Addendum #2

project: Intermountain Health Layton Hospital
Sleep Lab Remodel
201 West Layton Parkway
Layton, Utah 84041

ADDENDUM NO. 02

1 SLEEP LAB FINISH FLOOR PLAN
1/A131 | SCALE: 1/4" = 1'-0"

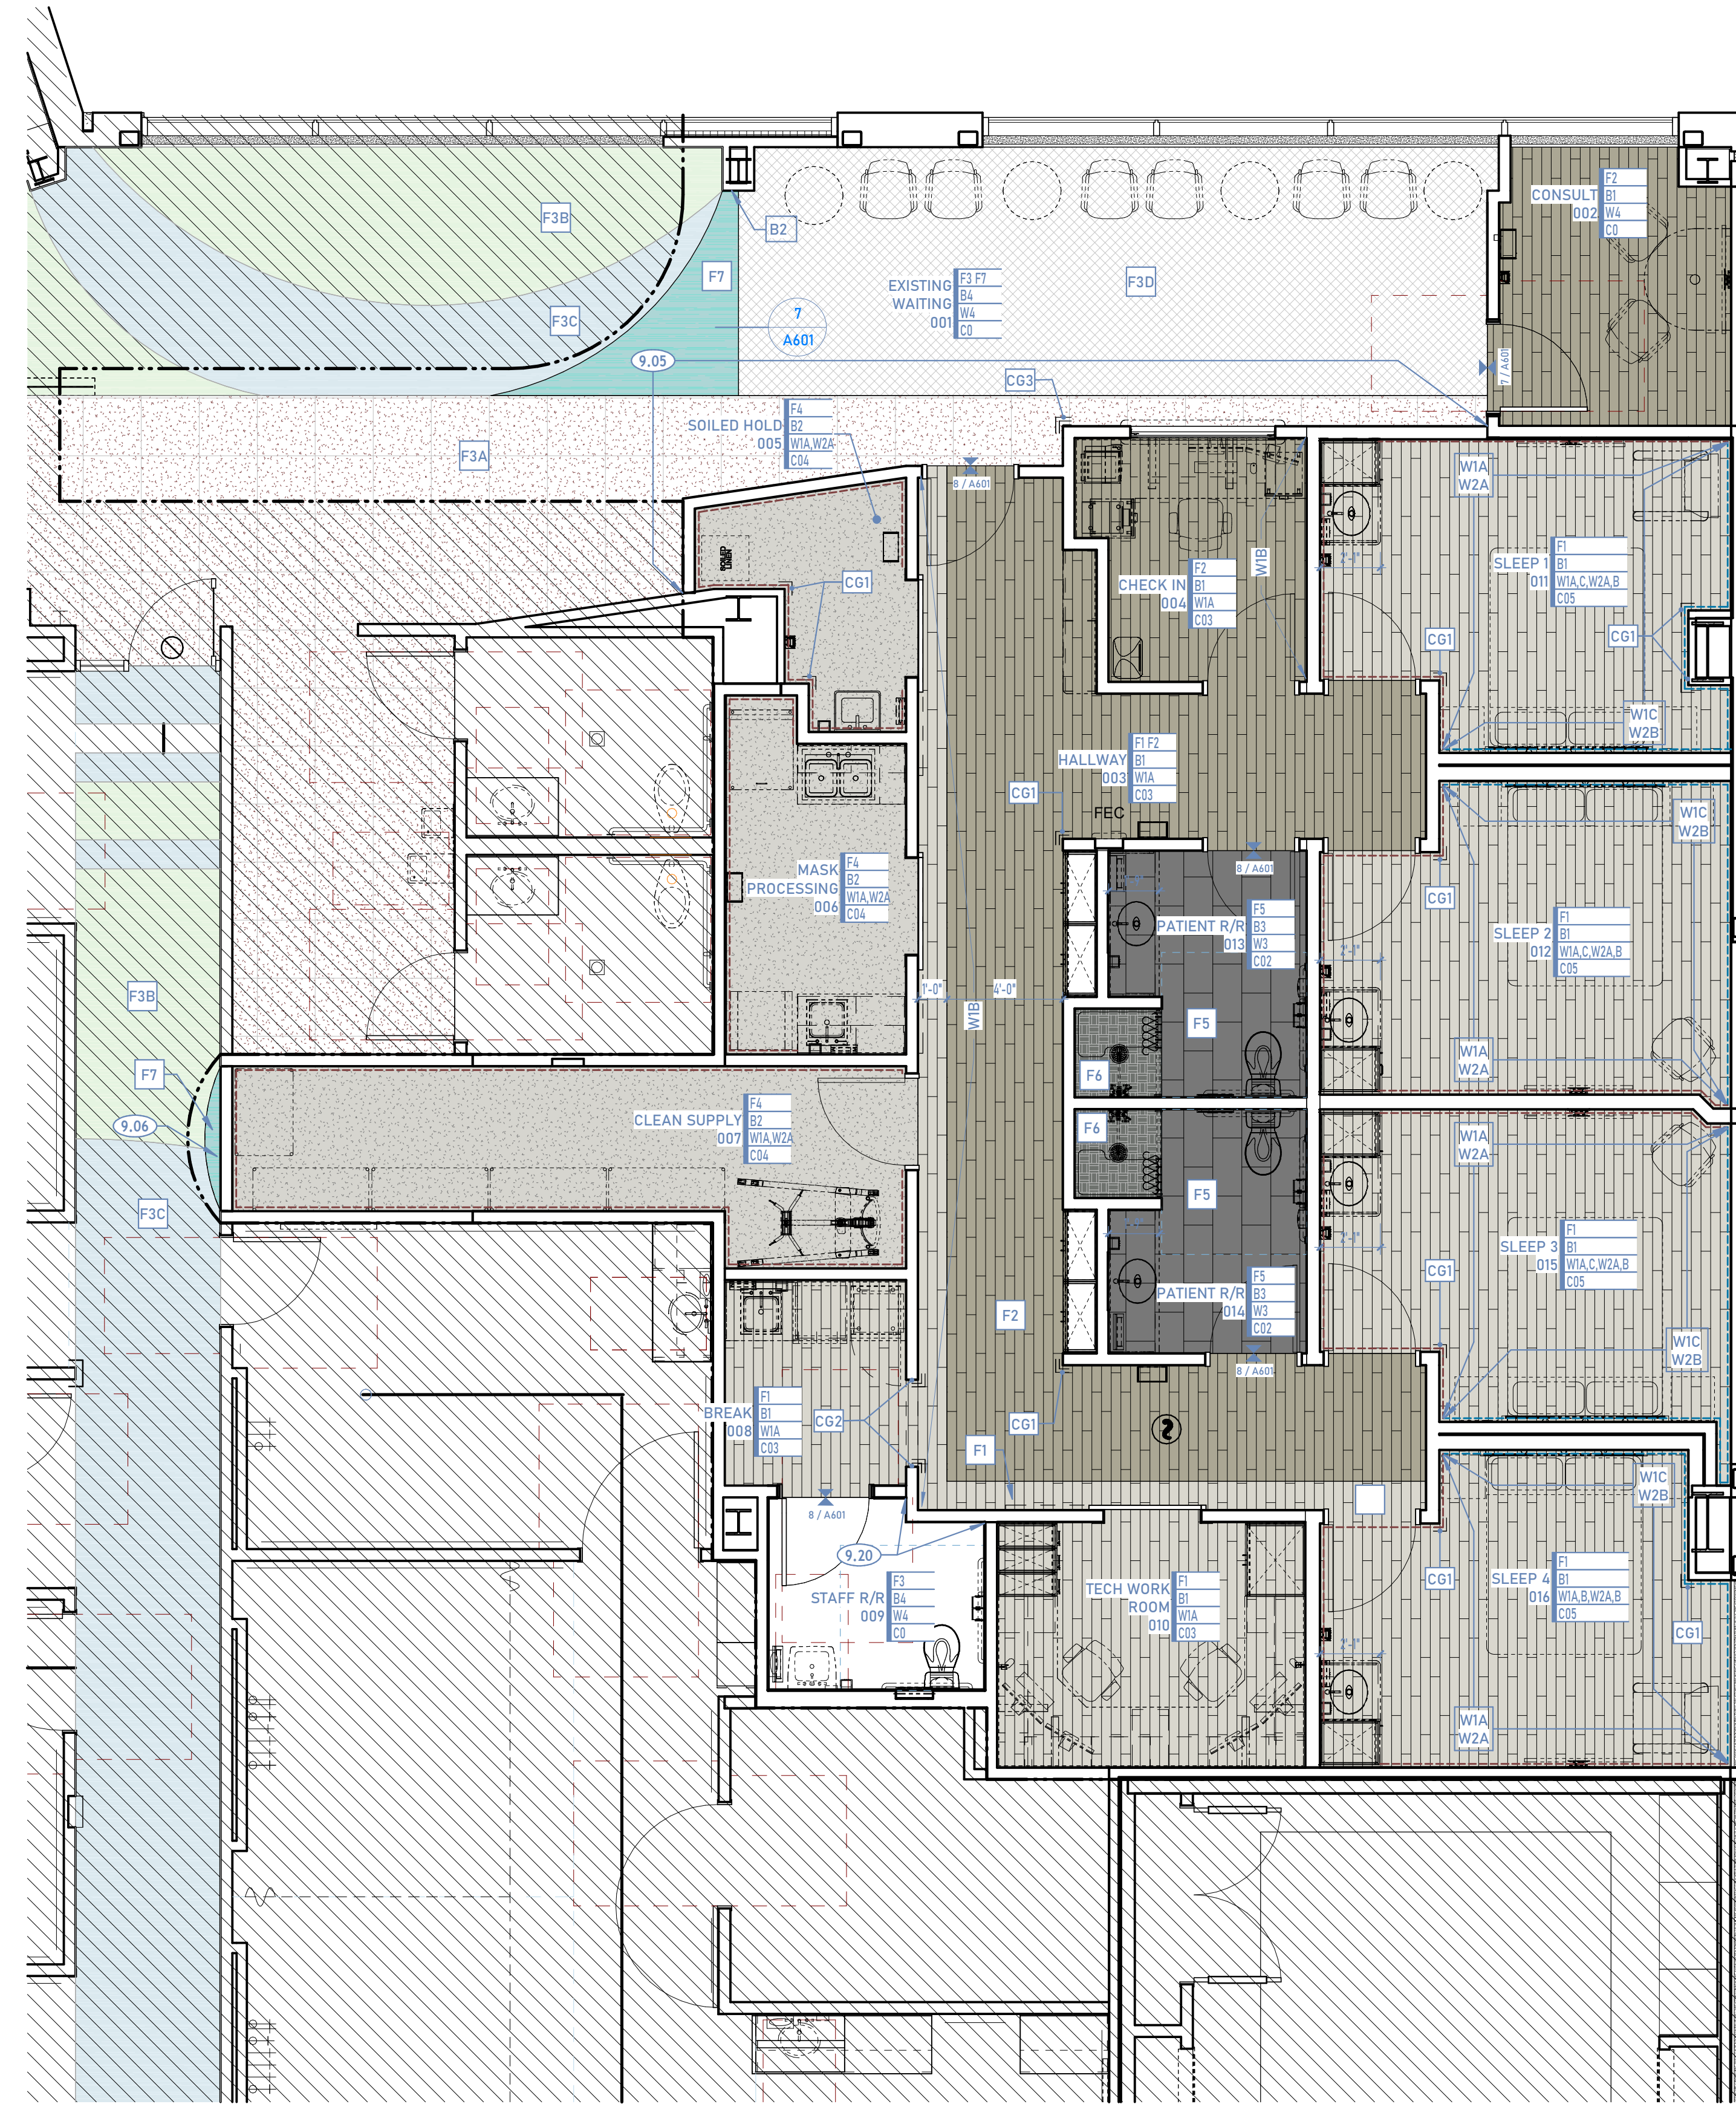
- A131/ 9.05 calls for new terrazzo base to match existing/ reuse where possible. Terrazzo cannot be reused in new locations. We can try to remove without damaging but it is highly unlikely. We would need a spec for terrazzo to provide a price for new terrazzo if this is desired

- We have added information to note 9.05 to call out the existing manufacturer / color. If you don't feel that it can be re-used then provide allowance price to replace. At the completion of the project the expectation is that terrazzo base to match existing in the lobby is continuous and that there is not a change order cost to accomplish this.

1 LEVEL 1 POWER PLAN
SCALE: 1/4" = 1'-0"

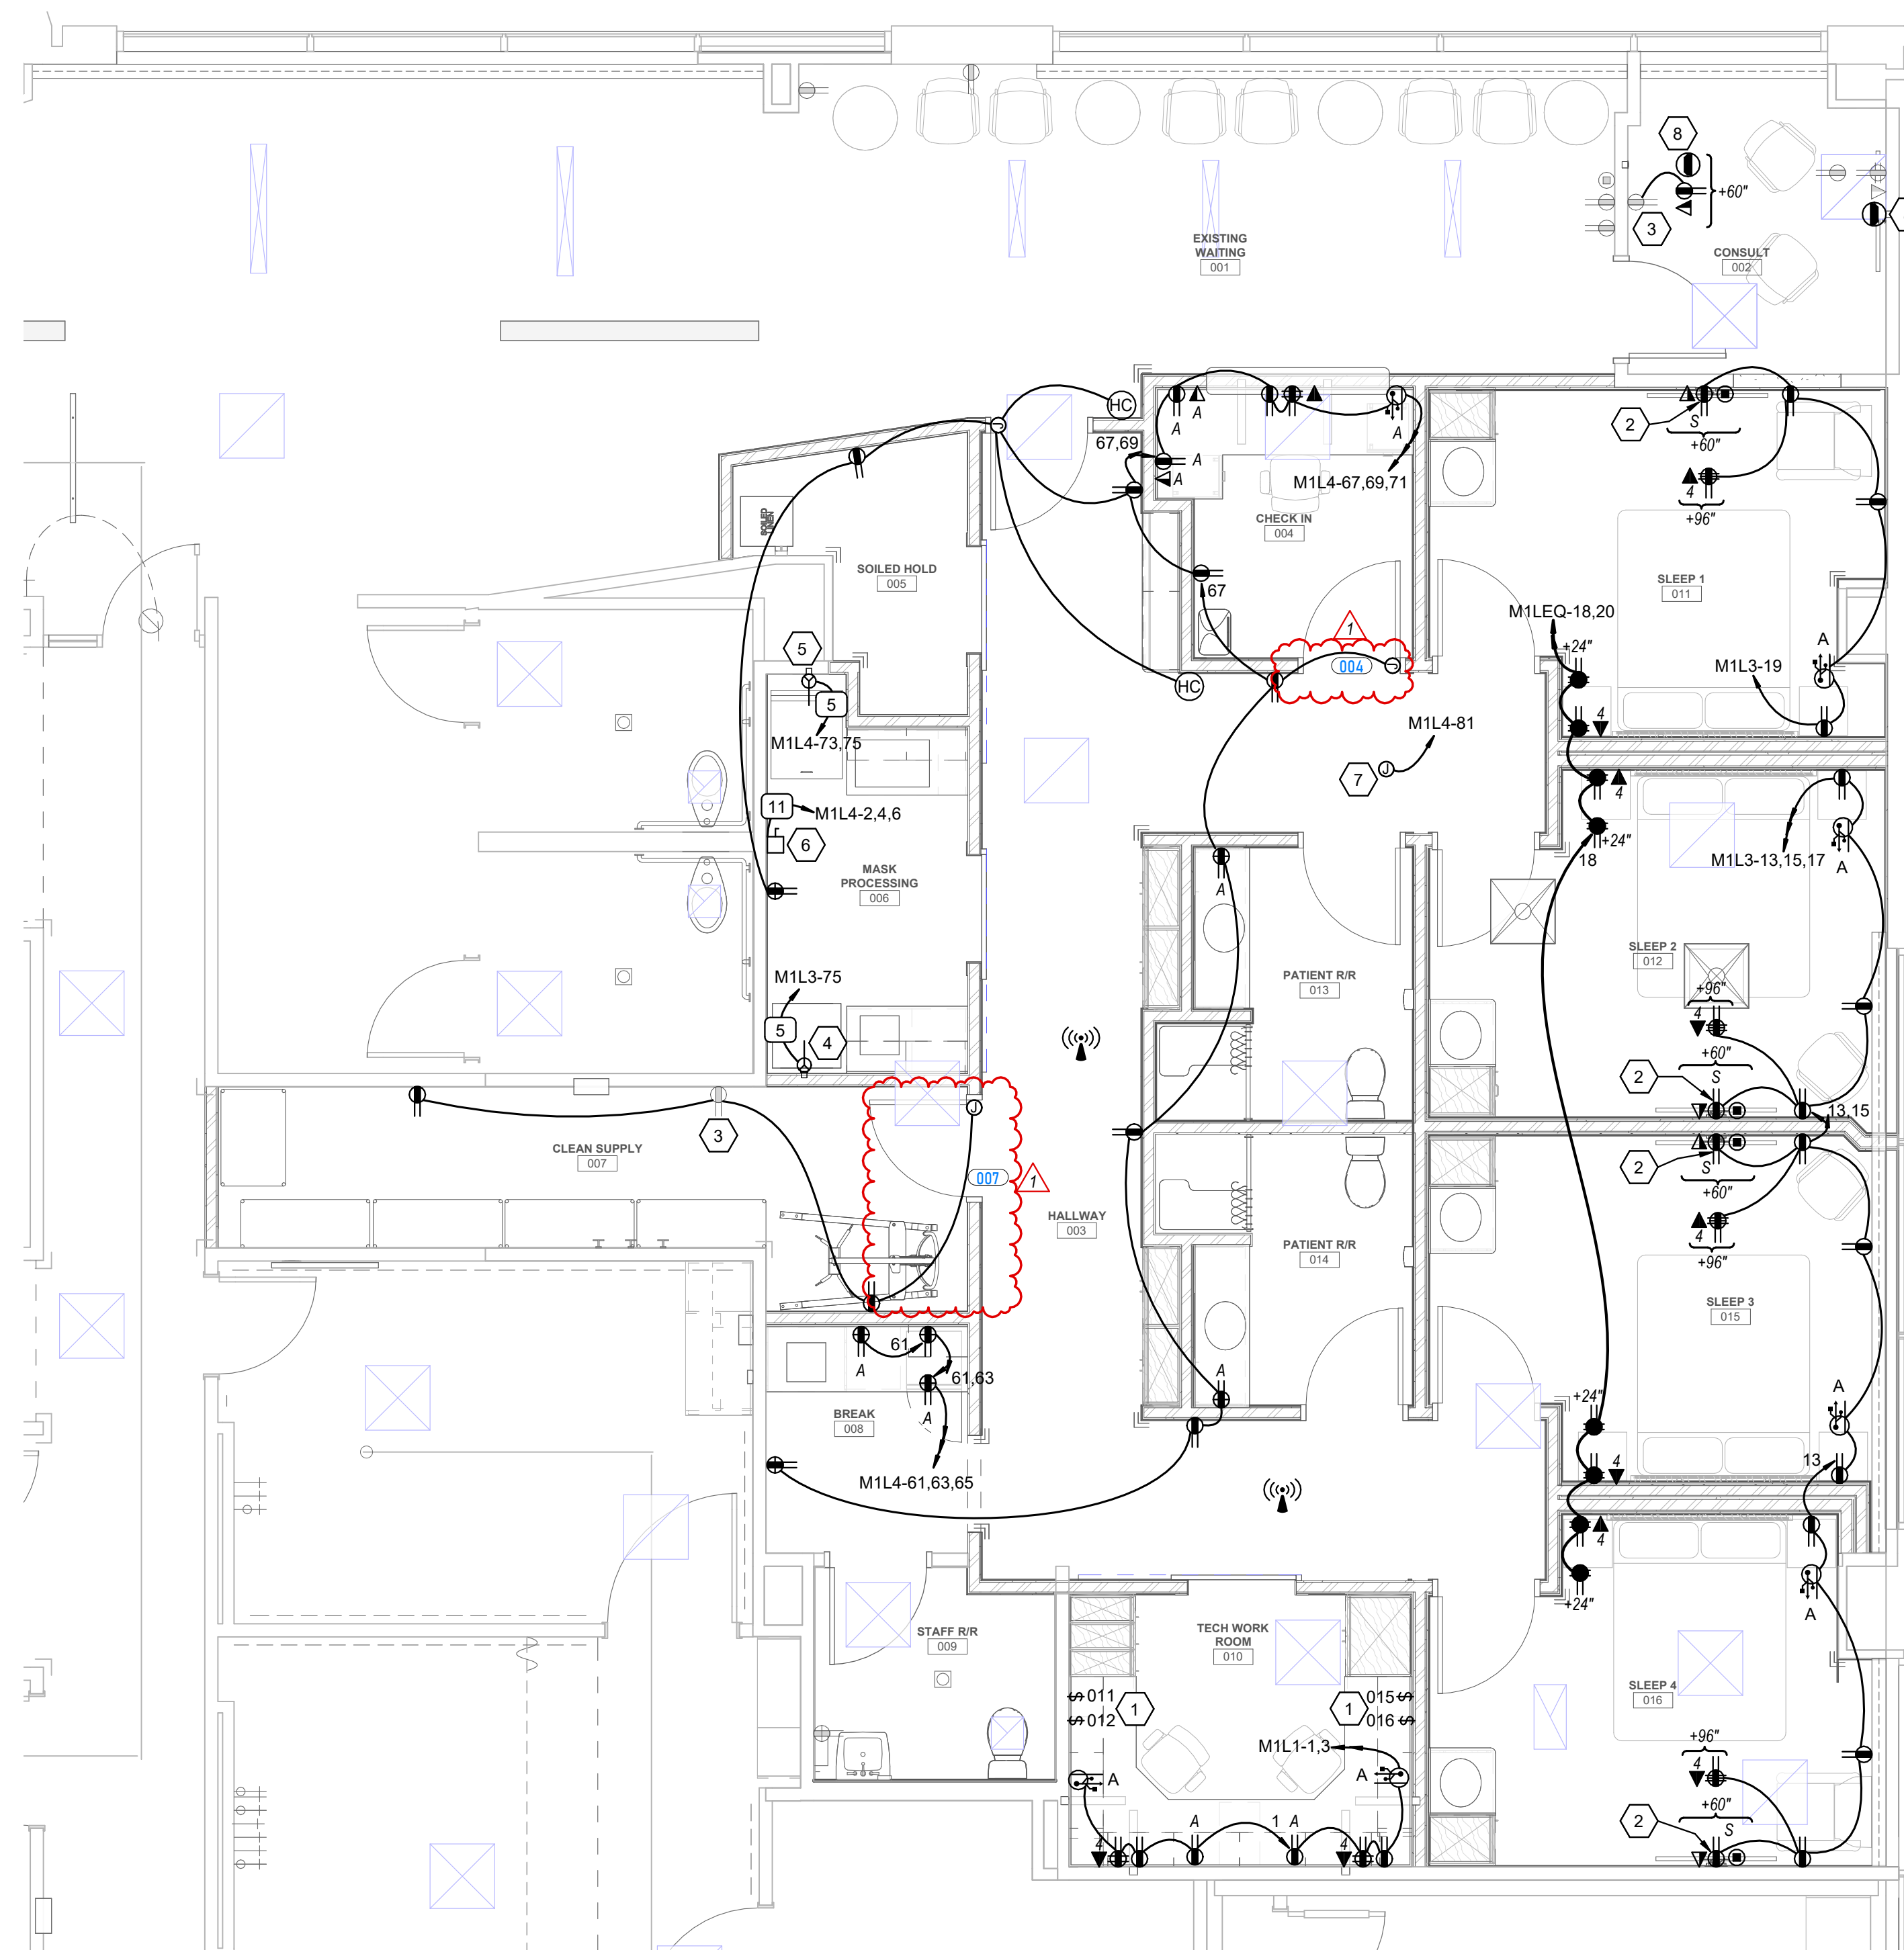
1. Added power for door hardware on door 004 and 007.
